Groundwater Transfer Review Summary Form

Transfer/PA # T- 14793

Application: T-14793

Applicant Name: Cook Landholdings, LLC

Map

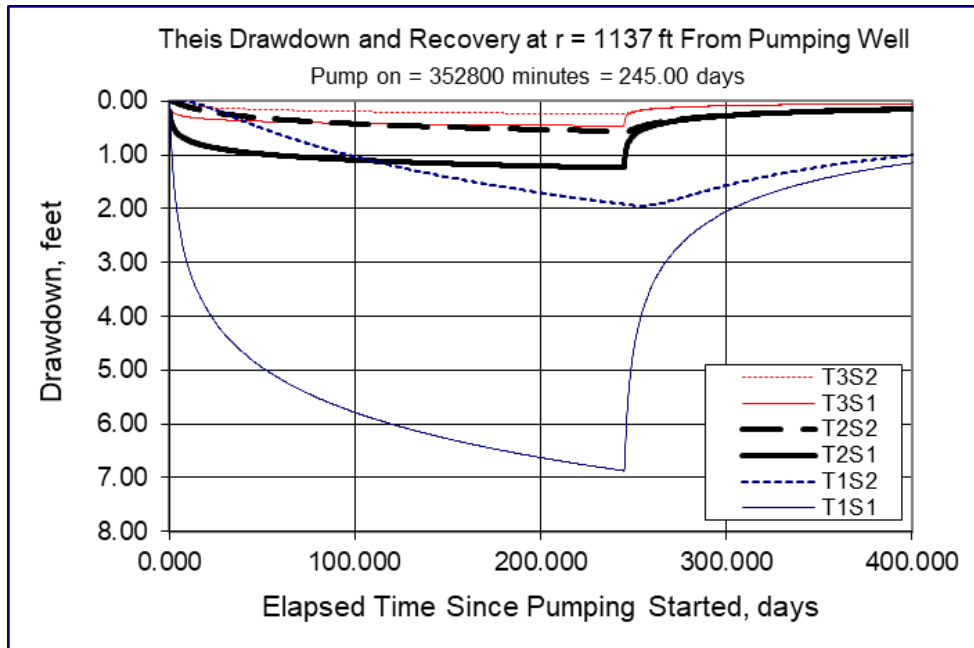
2. Will the proposed POA develop the same aquifer (source) as the existing authorized POA?
 - Yes No Comments: The authorized POA, Well 4 (LINN 57477) and the proposed APOAs, Well 3 (NLOG 58045) and Well 14 (LINN 5296), develop the unconfined Holocene alluvium.

5. a) Will this proposed change, at its maximum allowed rate of use, likely result in an increase in interference with **another ground water right**?
 - Yes No Comments: Well 3 (NLOG 58045) and APOA Well 14 (LINN 5296) are closer to LINN 5289, a POA authorized for irrigation per Certificate 89727 with priority date 4/8/1991. The reduced intervening distance is likely to result in an increase in interference with LINN 5289.
 - b) If yes, would this proposed change, at its maximum allowed rate of use, likely result in another groundwater right not receiving the water to which it is legally entitled?

Yes No If yes, explain: APOA Well 14 (LINN 5296) is 1,137 ft north of LINN 5289. The Theis (1935) solution for drawdown was used to assess the potential for injury to LINN 5289 from the proposed changes (see attached Theis Interference Analysis). Well 3 (NLOG 58045) is further from LINN 5289 than Well 14 (LINN 5296) and is expected to produce a lower interference with LINN 5289. Results indicate the proposed change is unlikely to result in LINN 5289 not receiving the water to which it is legally entitled.
